<p>6 City Center Exterior Renovations</p> <p>6 City Center Portland, ME 04101</p>		<p>Michael Charek Architects</p> <p>25 Hartley Street Portland, Maine 04103 (207) 761-0556</p>
--	--	---

<p>Title</p> <p>FIRST FLOOR PLAN</p> <p>REV. 9/15/16: H.C. TOILET ROOM DETAILS</p> <p>Scale: 1/8" = 1'-0"</p> <p>Date: 9/15/16</p> <p>Sheet</p>	<p>A1.2</p>
---	-------------

1 FIRST FLOOR PLAN
SCALE: 1/8" = 1'-0"

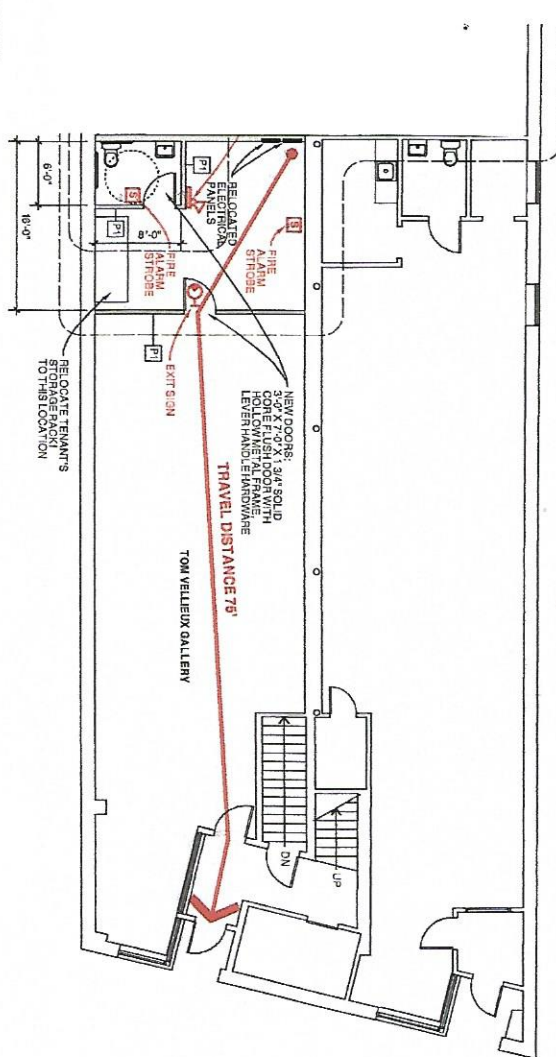
Is Permit Application 2018-00075 for more than tenant fit up of rail cabin? If not, please revise this note and the dashed line on floor plan.

Please show fire rating of partitions and UL listing number.

Does the existing building have a sprinkler system?
